Access Compliance Report

Public Rights-of-Way

(Curb Ramps)

Intersection ID: 25030	Main Street: CHILHAM_PL	Cross Street: RIDGELOCH_PL	Location:	S
ADA ID: 5374DDC4417E	Ramp Type: BlendTrans1	Initial Pass/Fail: Pass	Overall Compliance: No	Severity Score: 10
Codes/Mitigation Info/Possible Solution		Field Measurements/Component Compliance

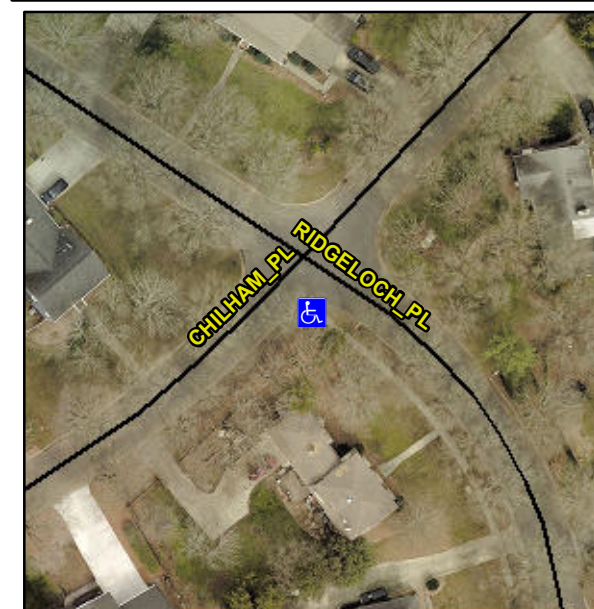
Not Found, R305

N/A	Ramp inside XWalk1?	N/A	N/A	Ramp inside XWalk2?	N/A
	Road Slope (%)	2.1		Clear Space?	Yes
	Road X Slope (%)	2.5	N/A	Clear Space to XWalk (in)	N/A
Yes	Any Obstructions?	No	Yes	Storm Grate/Utility Hazard?	No
	Obstruction Type			Storm Grate/Utility Type	
		N/A			N/A
			Yes	Surface Condition? (G/P)	Good
			No	Curb Slope (%)	5.1

Remove & Replace Curb Ramp With Two New Directional Ramps or Equivalent.
